SERVICE BULLETIN 01/2014

Subject: GP One – never exceed speed limitation

Airplanes Affected (s.n.): GP One, all flying aircrafts

- Photo of the Airspeed indicator (ASI)

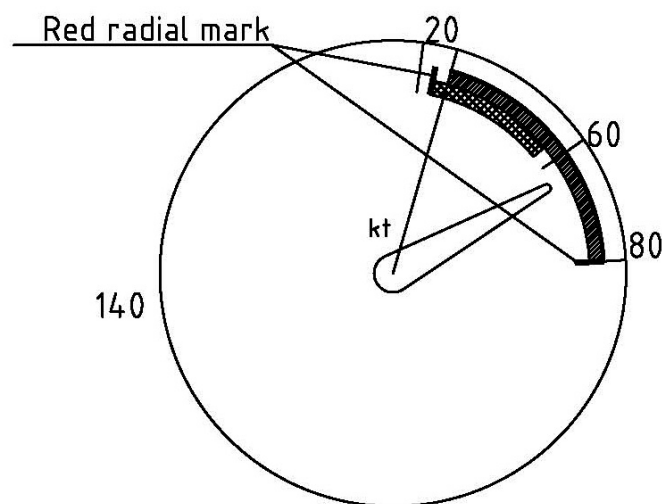
Reason: Flying at high airspeed can cause aircraft buffering and dangerous symptoms of flutter

Description: During flight test program it was established, that flying on top airspeed (approaching never exceed speed) can cause dangerous symptoms of flutter.

Action: Immediately perform an Airspeed indicator (ASI) re-marking to never exceed speed decrease to 80kt - via attached picture (in the bottom of letter).
